ADDENDUM NUMBER 06

NEW LEGISLATIVE PARKING GARAGE

DIVISION OF PUBLIC WORKS PROJECT NUMBER 81284

May 16, 2024

CHANGES TO THE DRAWINGS

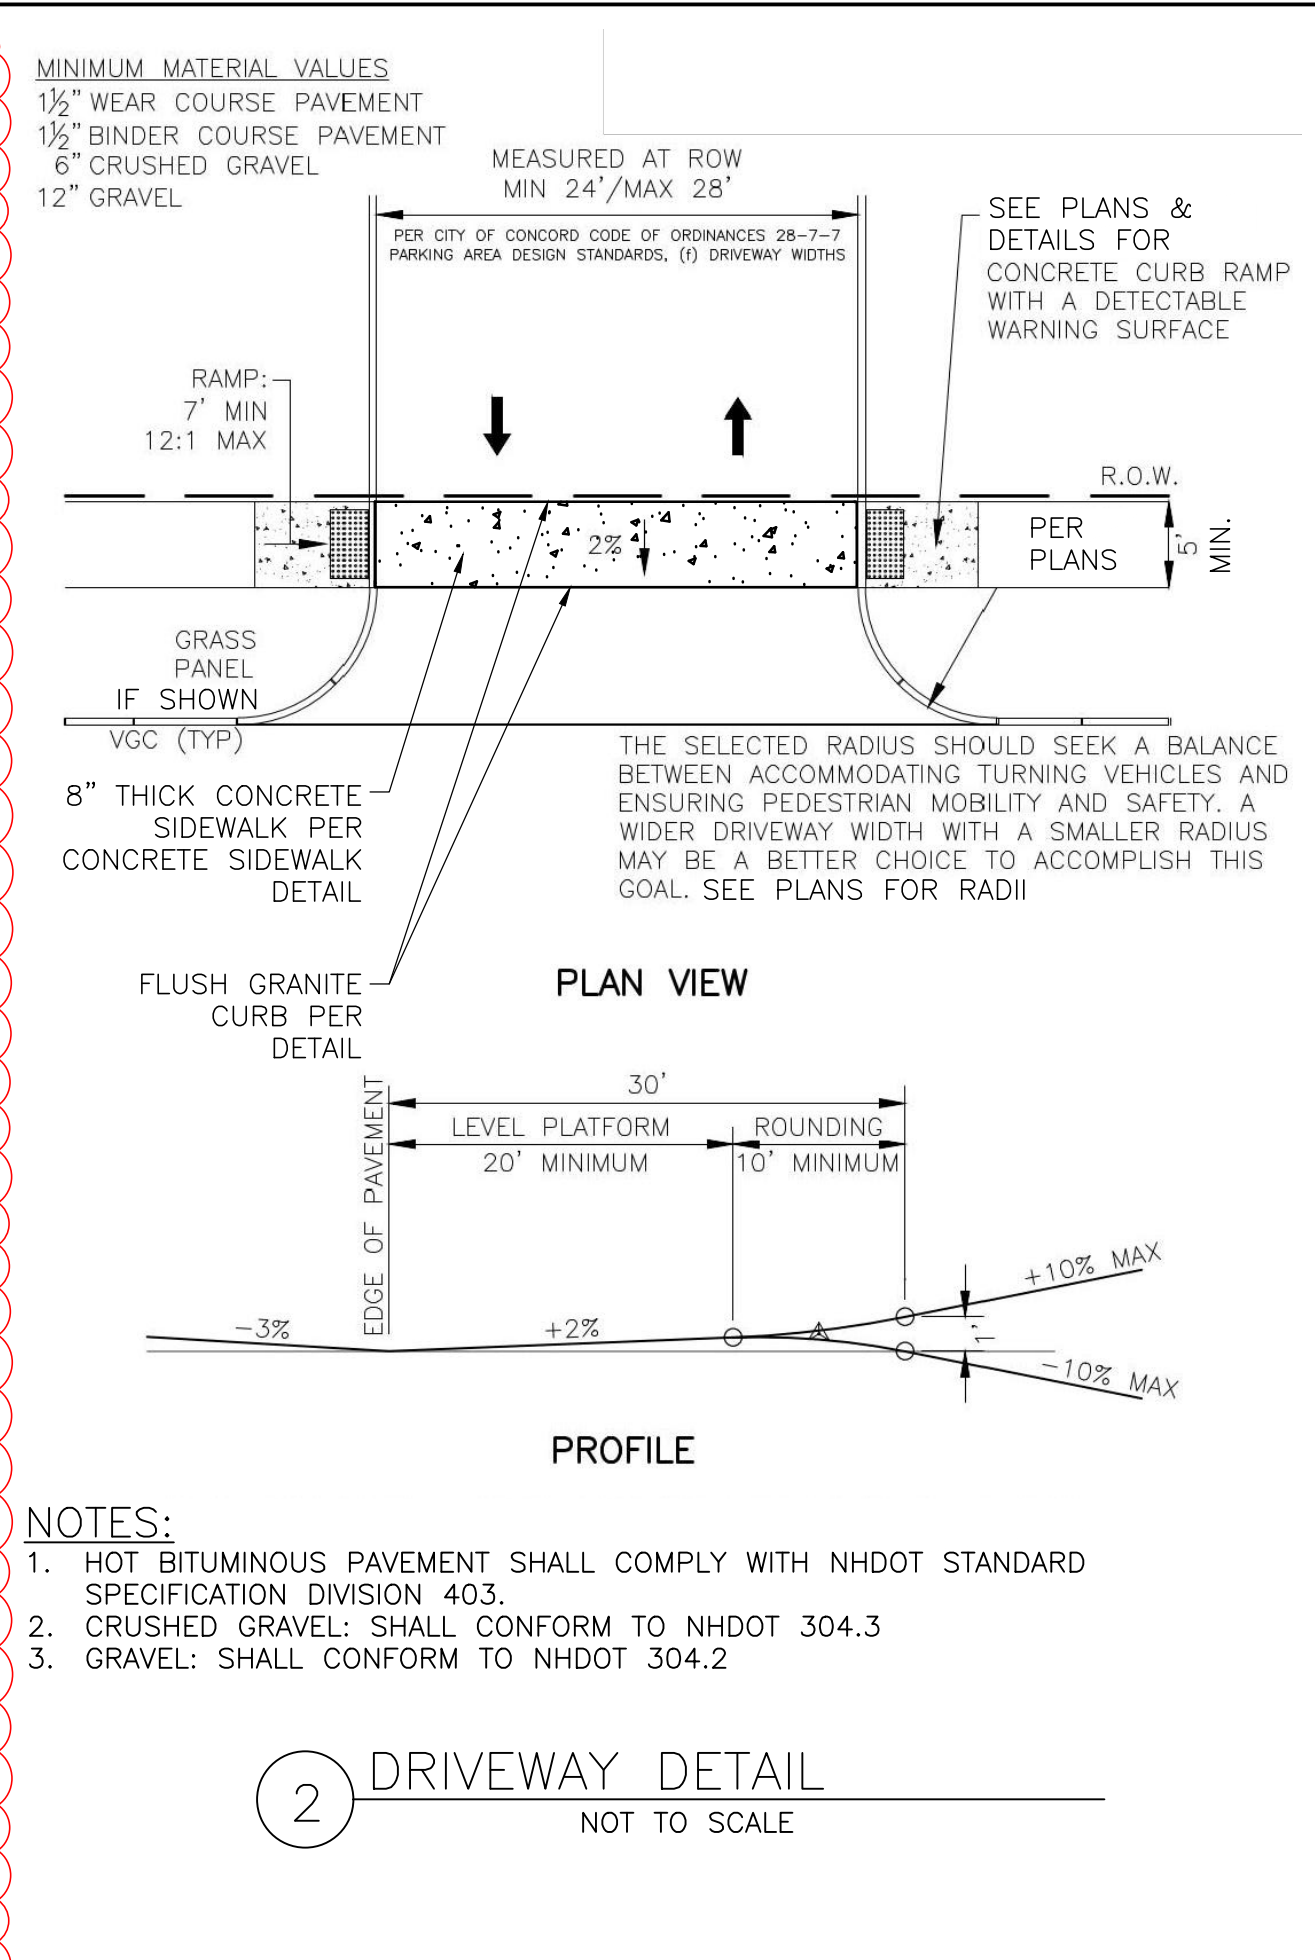
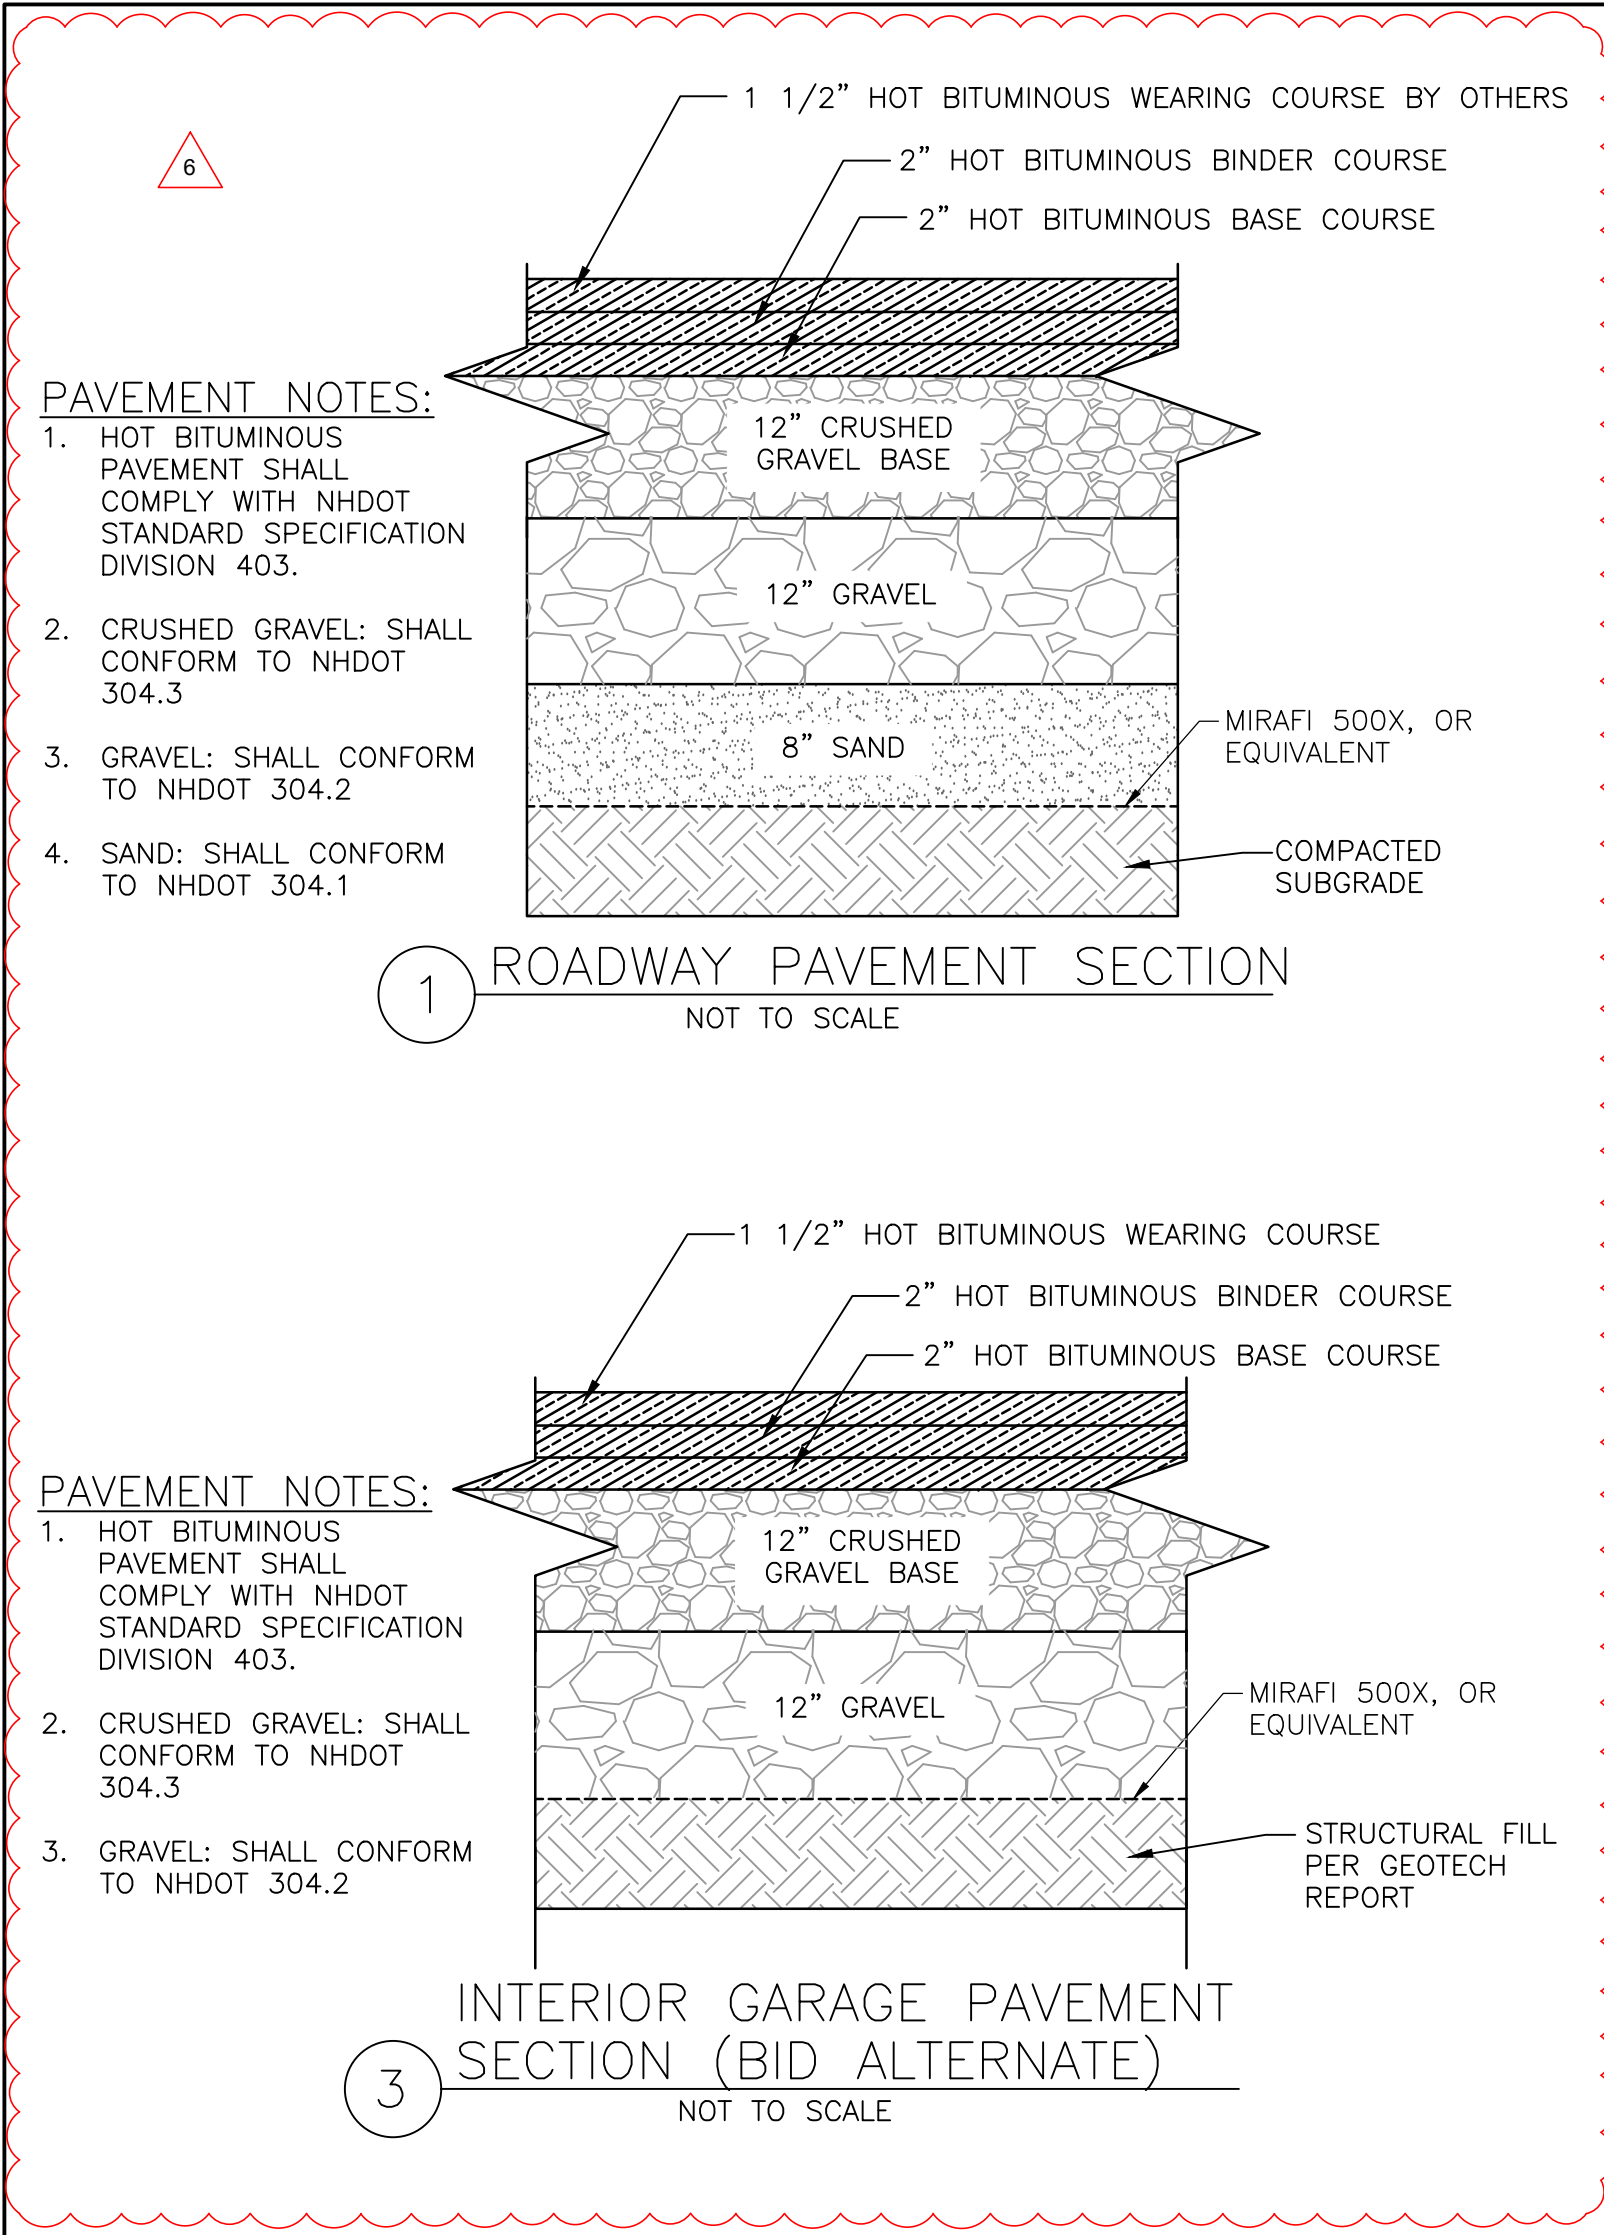
2. Q: The roadway paving detail 1/C5.01 indicates the final wearing course is to be paved by others. Is this the case? If this is the case, are structures within these areas be left 1.5” above grade? For the bid alternate, will this final paving course be by others according to 1/C5.01?

3. Q: In reference to Q&A #1 on Addendum #3 regarding parking garage asphalt thickness, the city street asphalt section is called out to be 5.5” thick of asphalt. Please confirm that 5.5” of asphalt is to be

placed on 1st floor of parking garage. In the detail, it also references top coat to be by others so where does that come in to play with the garage asphalt?

A. Street paving final wear course will be by others: Depending upon construction sequencing, the contractor shall either install the rim elevations to finished grade elevation (as they are currently shown within the plan set), or shall install the rims 1.5" below finished grade. Contractor to coordinate with the City of Concord to determine this elevation, but shall provide the flexibility for all proposed structures to be raised or lowered by utilizing a minimum of (2) courses of brick, and a maximum of (5) courses of brick per the City of Concord Standard Details.

B. Paving within the garage (bid alternate): No paving within the garage for the bid alternate will be performed "by others." Please see the revised Sheet C5.01.

A. Yes, 5.5” of asphalt is called for in the bid alternate for pavement in the garage. Please see response to question 2 above and reference revised sheet C5.01.

TYPICAL FLOOR DRAIN DETAIL
NOT TO SCALE

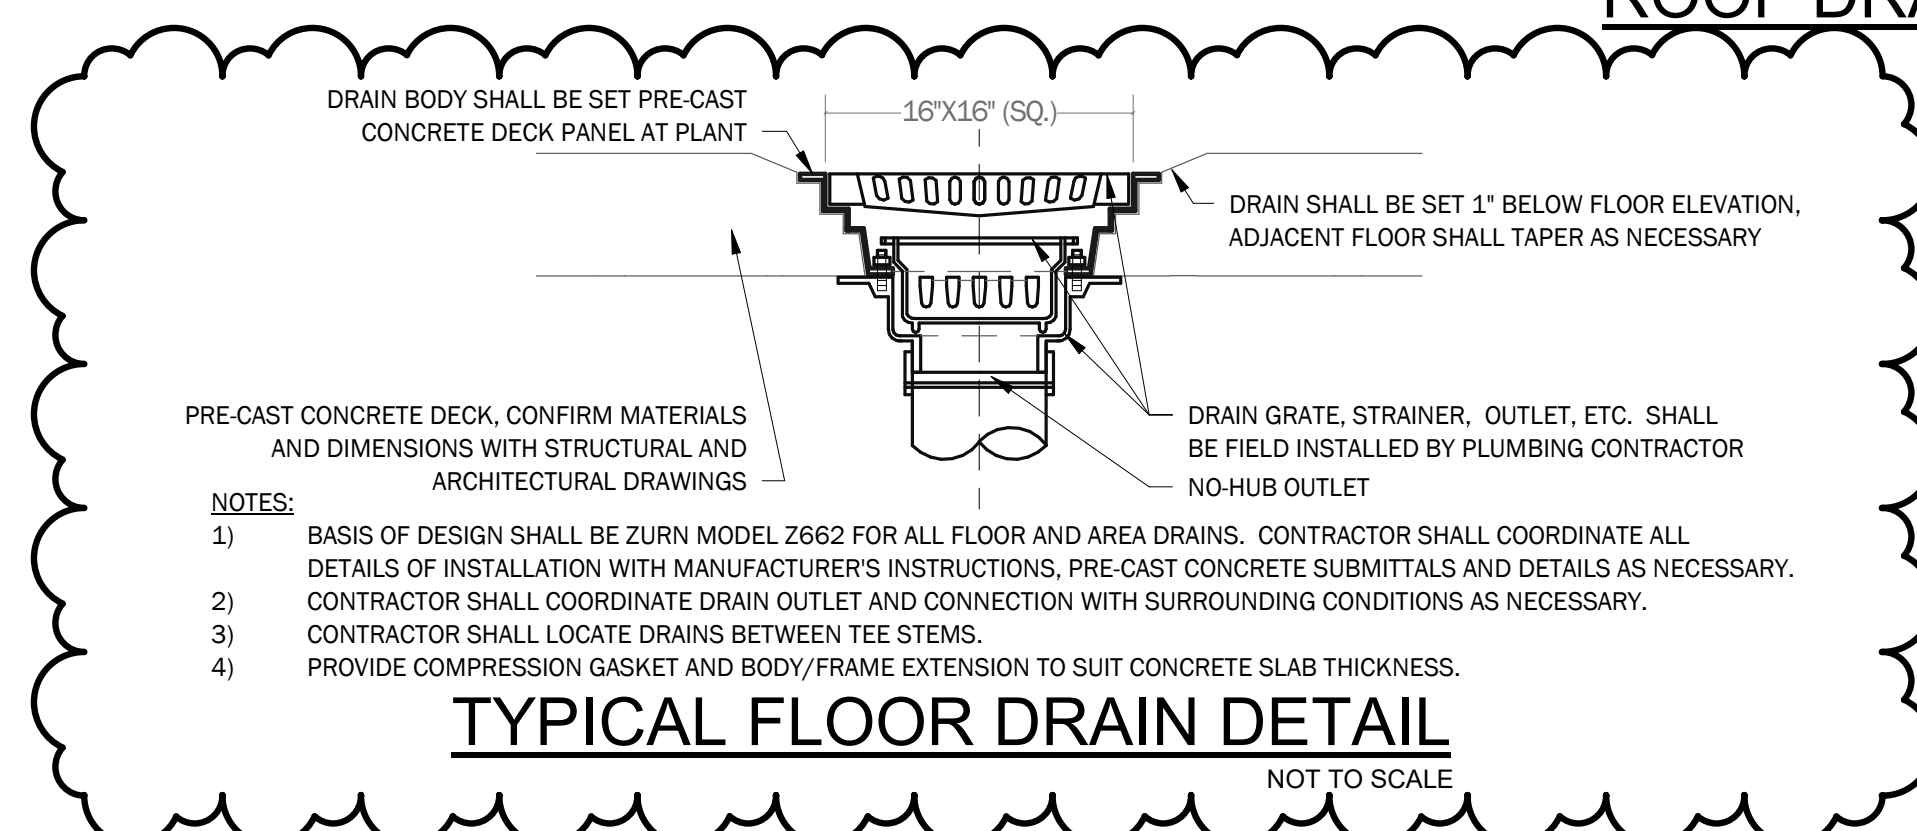
5. There are details for roof drains, and site drains on the plans. There are no details for ground floor or precast deck drains. Please provide detail for floor drains in precast deck, and at the ground floor (both for cast in place concrete floor and alternate asphalt floor).

A. Details are provided on the attached updated P5.0.

Plan showing area on site containing ACBM materials to be removed under this Contract - See attached test report on materials found at this location.

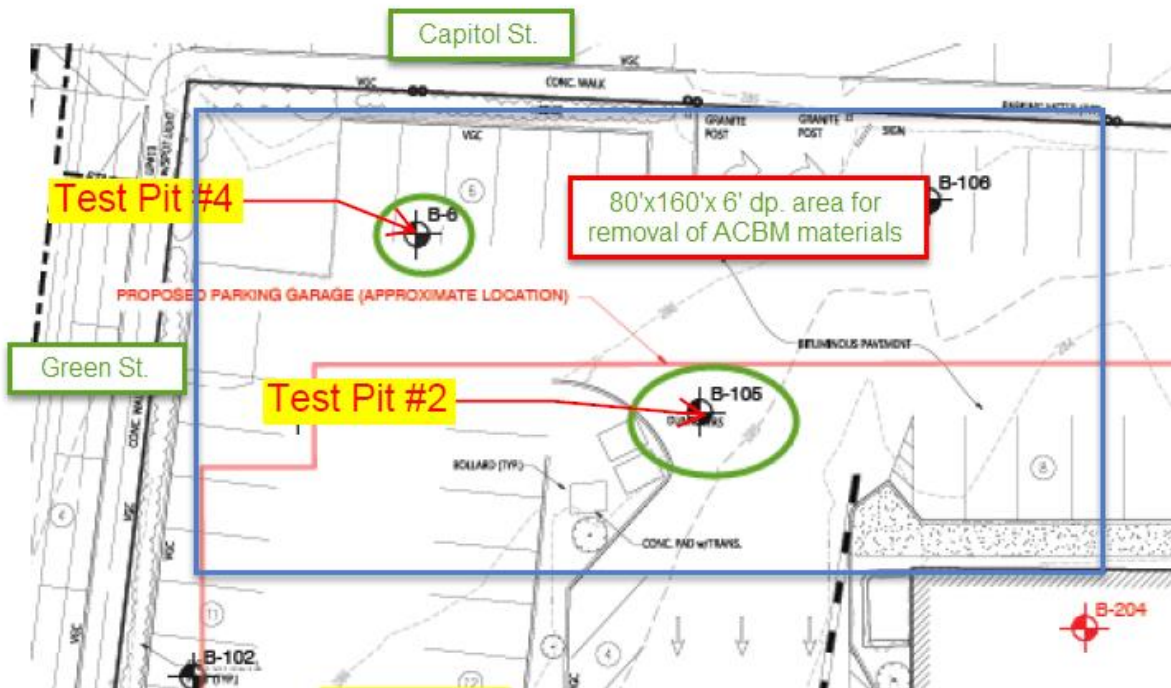
1. Q: Per Geotech report, all fill excavated will be “fill material with urban debris”. Do we need to figure this is contaminated material?

9. Hazardous Materials known to be on site: After demolition of the former DOJ building on the project site, exploratory test pits revealed a limited presence of known asbestos containing building materials (ACBMs) that will need to be removed and disposed of under State guidelines for regulated soils/materials. Bidders shall refer to Attachment #1 showing the general location of test pits and ACBMs along with the direction to remove existing soils in an area equivalent to 80’x160’x6’deep. Replacement materials shall be as indicated in the Civil and Structural plans for the new construction. Attachment #2 contains the test pit Analysis Report.

A. The State is having testing performed on the existing fill material. See Attachment #1, DOJ Test Pit and Soil Removal Plan (1 page), dated 5/3/24, and Attachment #2, DOJ Site Buried ACBM Materials – Test Report (12 pages), dated 5/3/24, for identification and extent of contaminated materials.
